**Project Title:** Roof Replacement  
Building 22  
Central Experimental Farm (CEF), Ottawa (Ontario)

**Solicitation No:** 14-1054

August 12, 2014

## Addendum 3

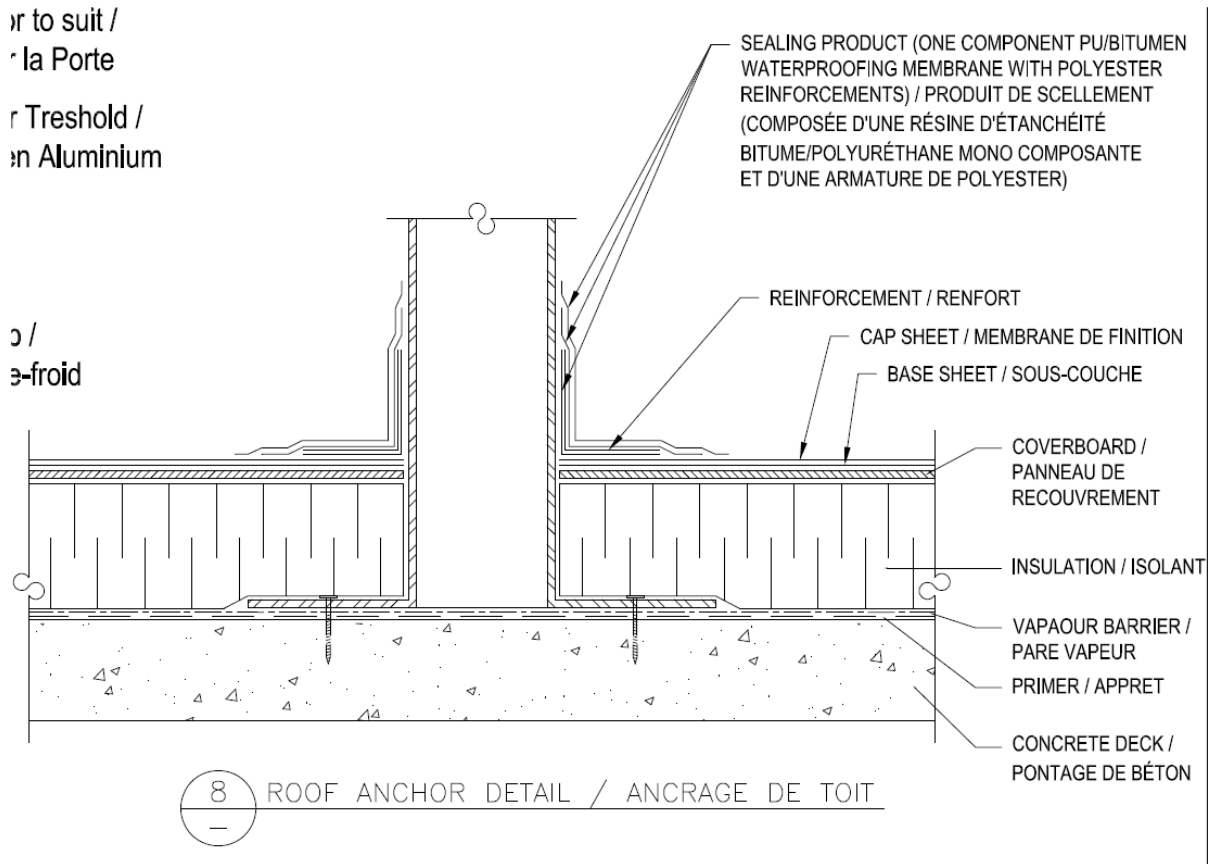
**Q8. Do we have to replace the Flexi-joints on mechanical units with new ones?**

A9. The Flexi-joints must be replaced as required, see the attached site photo.
